SUBJECT: Historic Area Work Permit #1106063 REVISION #3 – Accessory Structure Alteration

HAWP #: 1106063 at: 4 East Kirke St., Chevy Chase

4 East Kirke Street
Lot 30, Block 34,
Chevy Chase, Section 2
~ CHEVY CHASE VILLAGE ~
Pergola and Shed Building
Permit Site Plan

SHEET TITLE:
Building Permit Site Plan

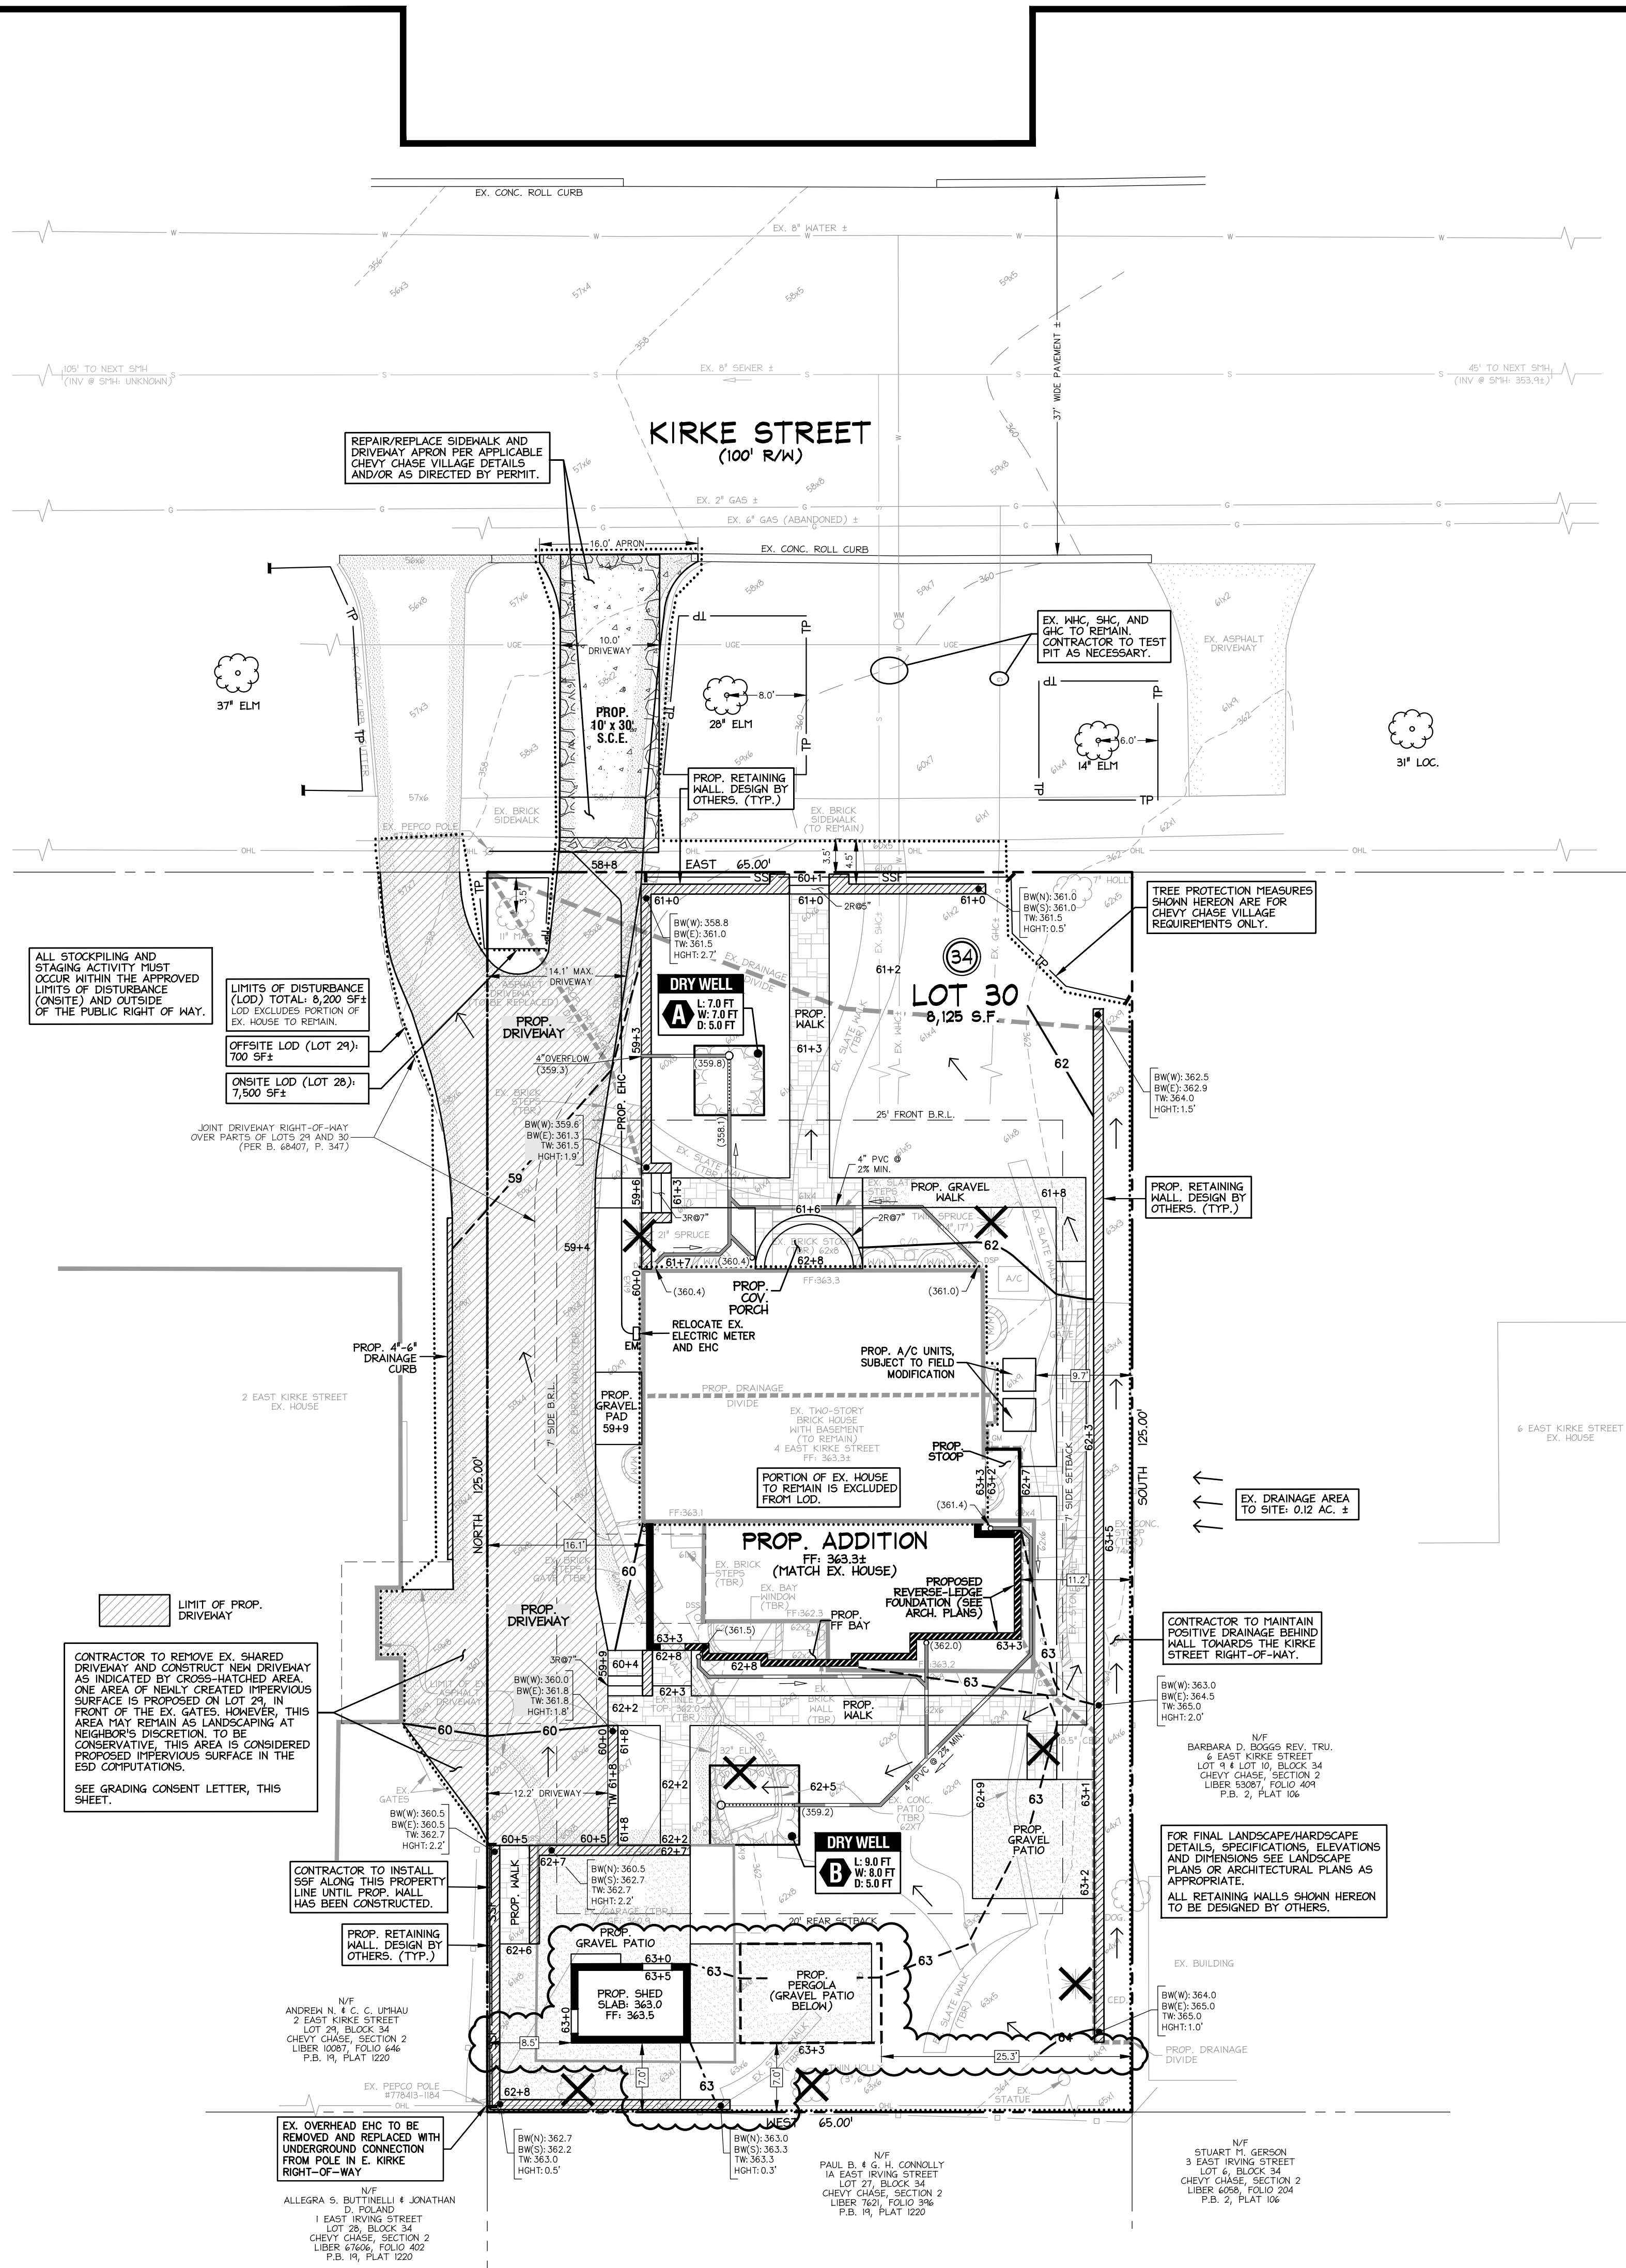
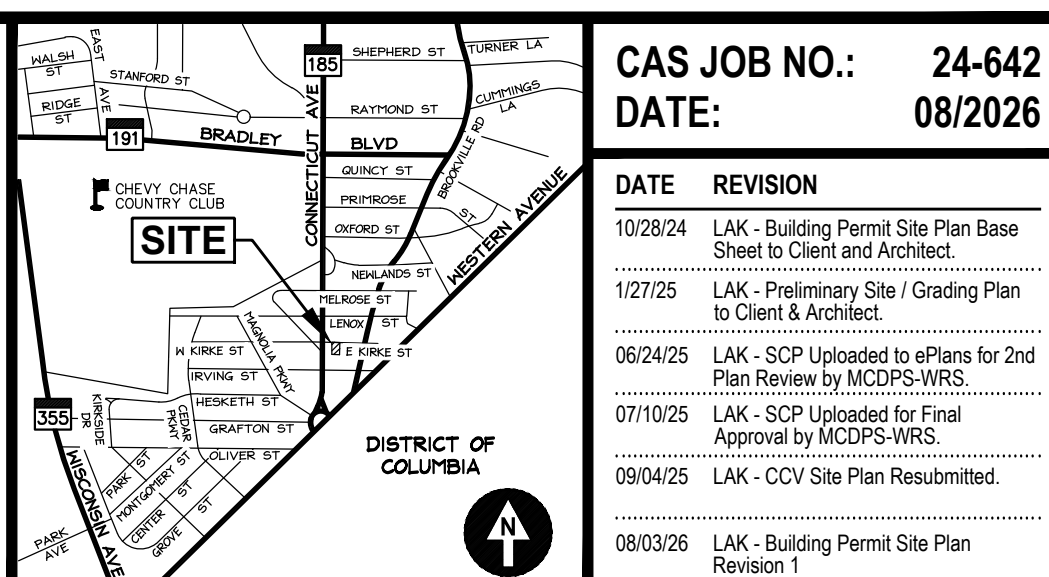
UPDATED SCOPE OF WORK INCLUDES
PROPOSED SHED AND PROPOSED PERGOLA.
SEE CLOUDED AREA ABOVE.
